Model: Iris/Lilac 3bin Sorter			Date	Date: 11-Dec-01		No.: MA849001	
Modified Article: Antistatic Brush				Prepared by: M.Tsuyuki			
From: Technical Services Dept., GTS Division							
Reason for	☐ Parts catalog correction	☐ Vendor change		☐ To n	neet standards		
Modification:	☐ To facilitate assembly ☐ To improve		ve reliability ()		
	☐ Part standardization	Othe	r

Modification Bulletin

Model: Iris/Lilac 3bin Sorter Date: 11-Dec-01 No.: MA849001

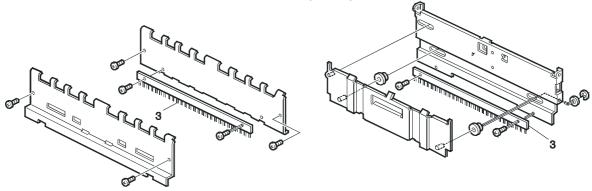
The Antistatic Brush has been modified so that the fibers remain firmly attached to the brush, which will ensure that SC410 is not triggered when paper is re-fed from the bypass tray to print the 2nd side.

Old part number	New part number	Description	Q'ty	Int	Page	Index	Note
AA120027	A8491661	Antistatic Brush	4	X/O	7 9 11	15 24 3
